Service Bulletin

WBH-16 Fuel Tank Vent Valve and Vapor Hose Update

Product Group: Concrete Buggies	Date Issued: 08/07/12	Service Bulletin No. CB20120806
Bulletin Type <input checked="" type="checkbox"/> Mandatory <input type="checkbox"/> Information Only <input type="checkbox"/> Recommended Change		Models/Series Affected: WBH-16 110401 ~ 120610

Figure 9. Removing Roll-Over Valve

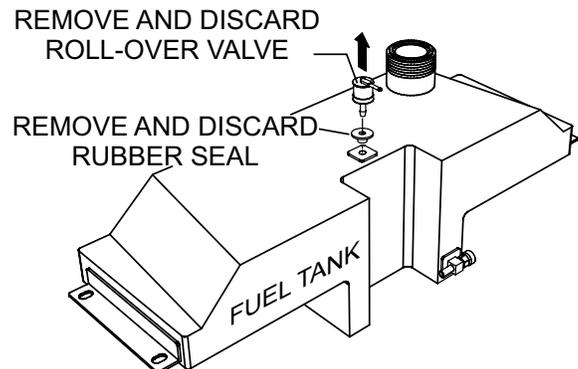
1. Use a flat head screwdriver to remove the roll-over valve and rubber seal from the fuel tank as shown in Figure 9.

Figure 10. Pipe Plug Tap Hole

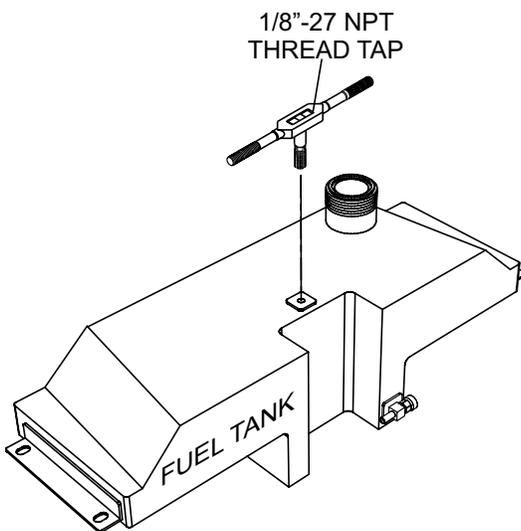
1. Place fuel tank on a suitable workbench free of dirt and debris.
2. Before tapping or drilling ensure tank is dry and all vapors have evaporated. Have a fire extinguisher nearby in case of fire.
3. Using a 1/8"-27 NPT thread tap (Figure 10), thread the hole where the existing roll-over valve was installed.

Figure 11. Vent Valve Drill Hole

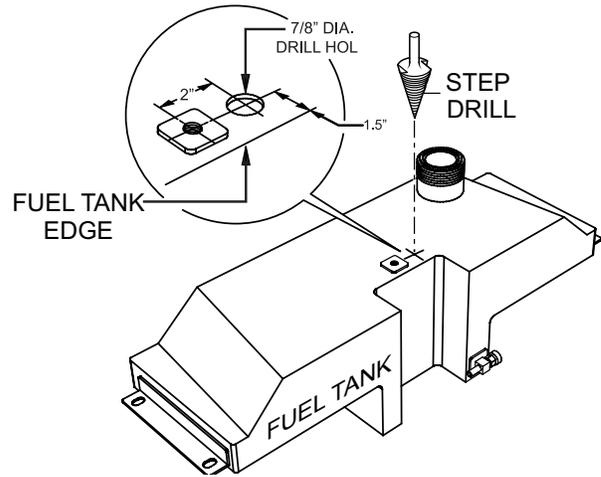
4. Next, using a step drill or equivalent drill bit, drill a 7/8-inch diameter hole as shown in Figure 11. This hole is necessary for the new vent valve.
5. After the hole has been drilled, deburr the hole opening and remove any rough edges.

Figure 12. 1/8" Pipe Plug Installation

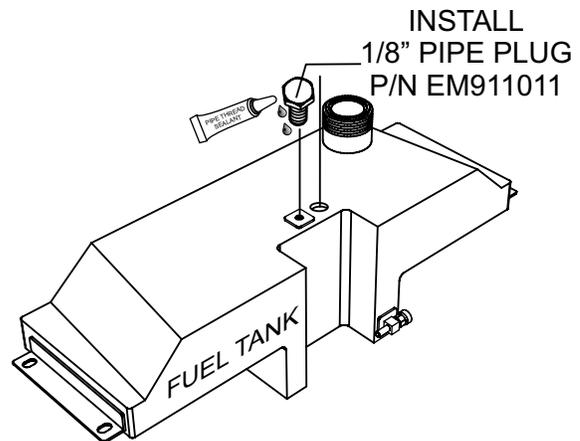
1. Apply fuel resistant sealant (Figure 12) to the threads of the new 1/8-inch pipe plug (P/N EM911011) to be installed on the fuel tank.
2. Insert 1/8" fuel tank pipe plug into the threaded hole where roll-over valve was installed.

Figure 13. Vent Valve Installation

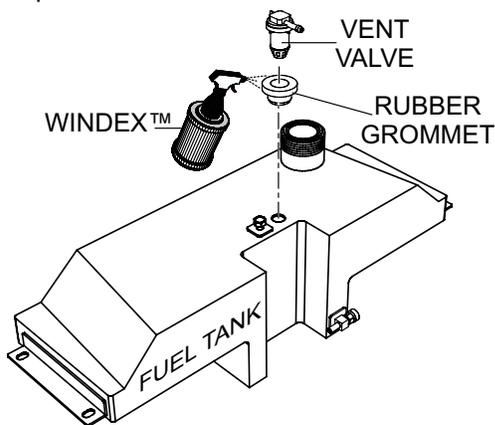
1. Spray the inside and outside of the vent valve grommet with Windex™ or an equivalent solution as shown in Figure 13. This will make it easy to fit the grommet onto the vent valve.
2. Twist and turn the vent valve while applying pressure to insert onto grommet.
3. Insert vent valve with grommet attached into fuel tank as shown in Figure 13. Please note orientation of vent valve port.

Figure 14. Air Filter/Fuel Tank Vapor Hose Clamps

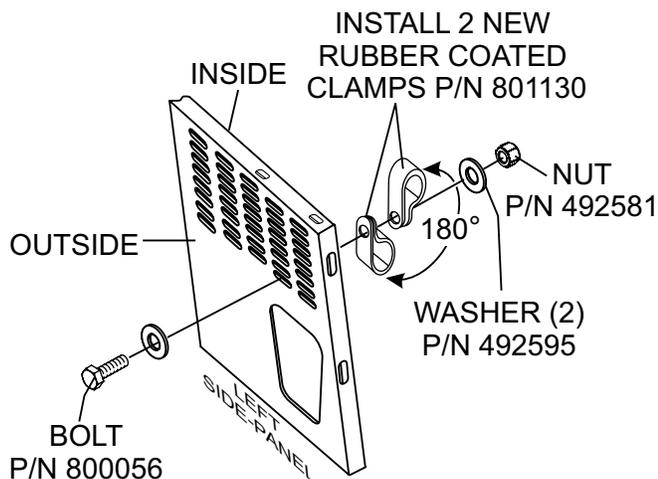
4. Install 2 new rubber coated clamps (P/N 801130) to the buggy left-side panel (Figure 14). **NOTE**, these clamps must be installed 180° opposite of each other.
5. From the operator's position, secure both clamps to the buggy's left-side panel using the supplied hardware, bolt (P/N 800056), washer (P/N 492595) and nut (P/N 492581).

Figure 15. Air Filter Vapor Hose Components

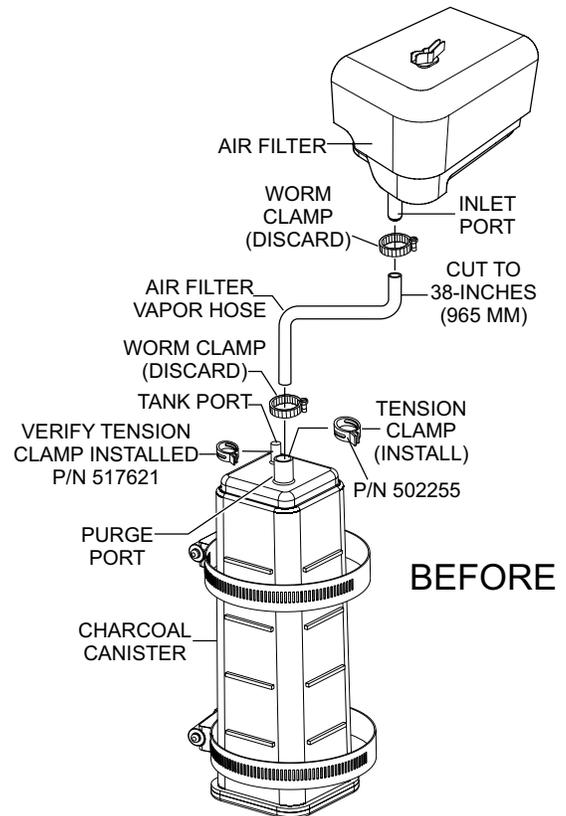
The 1/4-inch diameter vapor hose connecting the air filter to the charcoal canister needs to be shortened in length. This is necessary to allow installation of a 1/4" to 3/16" hose reducer.

1. At the charcoal canister (Figure 15) remove the air filter vapor hose and worm clamp from the charcoal canister **purge port**. Discard worm clamp.

2. Next, disconnect the other end of air filter vapor hose from the air filter inlet port. Discard worm clamp.
3. Place air filter vapor hose on a suitable work bench and cut to 38 inches (965 mm).

Figure 16. Hose Reducer Installation

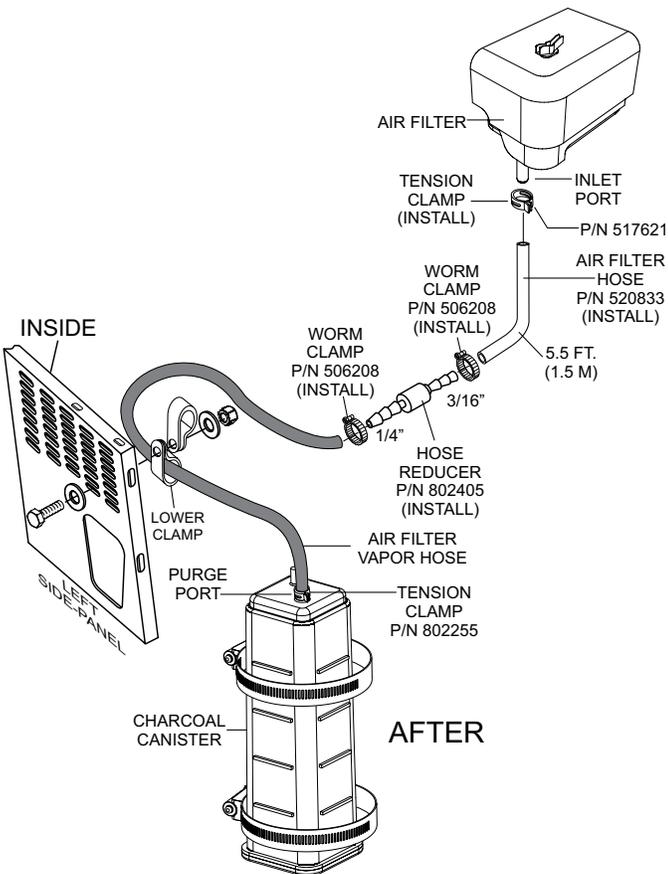
The hose reducer (Figure 16) is required to provide a better connection using the provided 3/16" hose to the air filter inlet port.

- Locate the free end of the air filter vapor hose and using supplied worm clamp (P/N 506208) connect it to the 1/4" side of the hose reducer.

- Next, using the supplied worm clamp (P/N 506208) connect the supplied 5.5" section of hose (P/N 520833) to the 3/16" side of the hose reducer.
- Finally, using the supplied tension clamp (P/N 517621) connect the free end of the 5.5 section of hose to the air filter inlet port.

Figure 17. Securing Hose Reducer

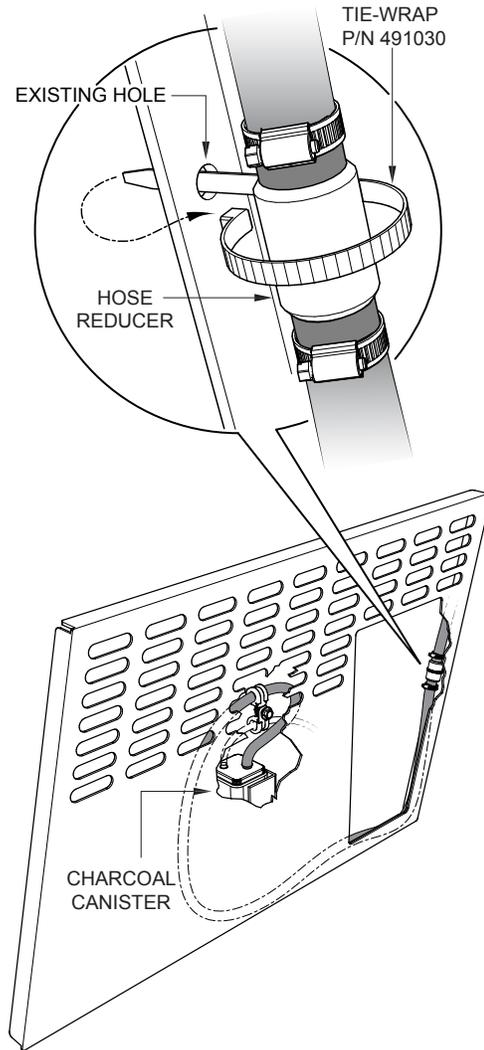
- Using the supplied tie-wrap (P/N 491030) secure the 1/4" to 3/16" hose reducer to the buggy as shown in Figure 17.

Figure 18. Fuel Filter Tension Clamps

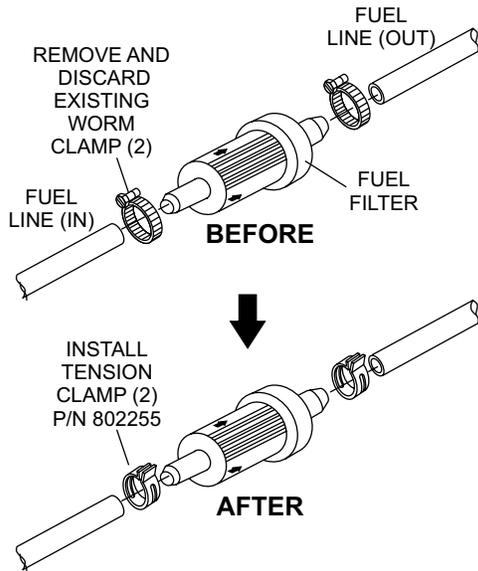
The existing worm clamps (2) that secure the fuel filter to the fuel hose lines need to be replaced with tension type clamps (2). Replace existing worm clamps as shown in Figure 17.

- When removing existing worms clamps from the fuel filter, fuel may begin spill. Wipe up any spilled fuel immediately.
- Remove both existing worm clamps from the fuel filter. Discard both worm clamps.
- Install new replacement tension clamps (P/N 802255) in place of the worm clamps.

Figure 19. Installing Fuel Tank Vapor Hose Clamp

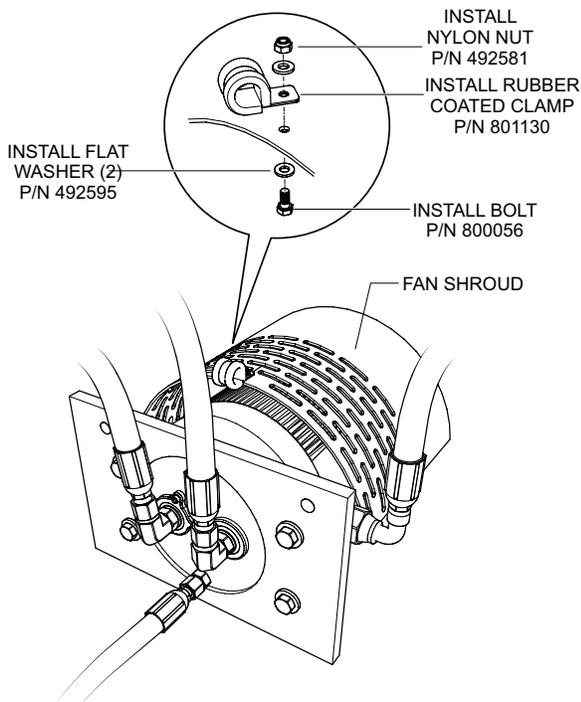
1. Cut and remove existing tie-wrap securing fuel tank vapor hose to fan shroud.
2. Secure rubber coated clamp (P/N 801130) to **fan shroud** (Figure 19) using the supplied hardware, bolt (P/N 800056), 2 washers (P/N 492595) and nut (P/N 492581).

Figure 20. Fuel tank Vapor Hose Routing

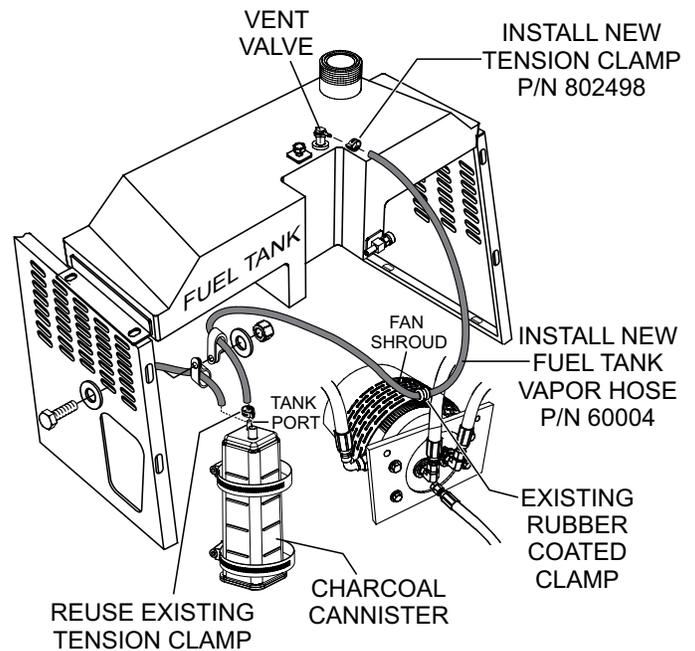
3. Place fuel tank on top of buggy side panels.
4. Connect the new fuel tank vapor hose line (P/N 60004) to the tank port on the charcoal canister (Figure 20) using the tension clamp from the original discarded vapor hose.
5. Route new fuel tank vapor hose thru newly installed upper rubber coated hose support clamp (Figure 14) on buggy left-side panel.
6. Next, route fuel tank vapor hose thru existing rubber coated clamp on the fan guard (Figure 20).
7. Lastly, connect fuel tank vapor hose to the fuel tank vent valve (Figure 20) and secure with tension clamp (P/N 802498).

Figure 21. Tank Neck Seal Installation

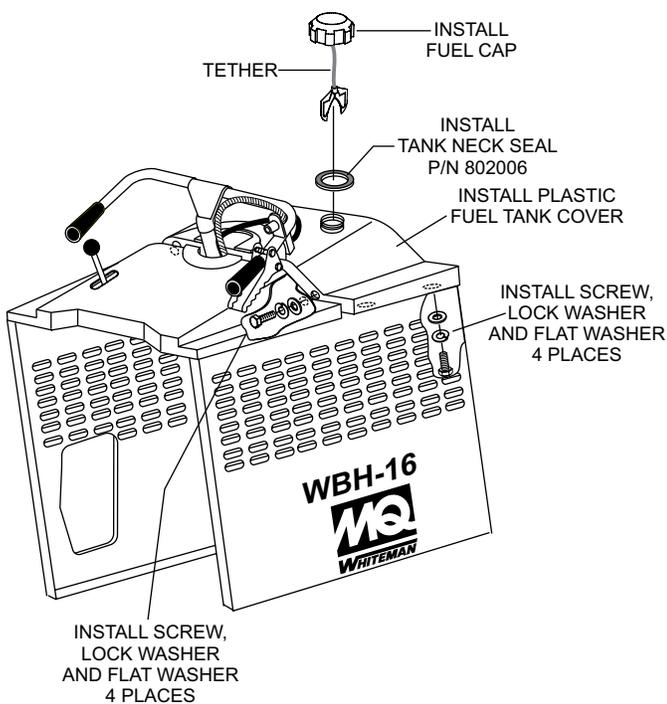
In some instances, gasoline spilled during refueling may run down the neck of the fuel tank and make contact with the hot muffler or other engine components.

To prevent this from occurring, a ***fuel tank neck seal*** must be installed over the fuel tank filler neck.

1. Place fuel tank plastic cover over fuel tank and secure both the fuel tank plastic cover and fuel tank to the buggy side panels.
2. Install new fuel tank neck seal (P/N 802006) as shown in Figure 21.
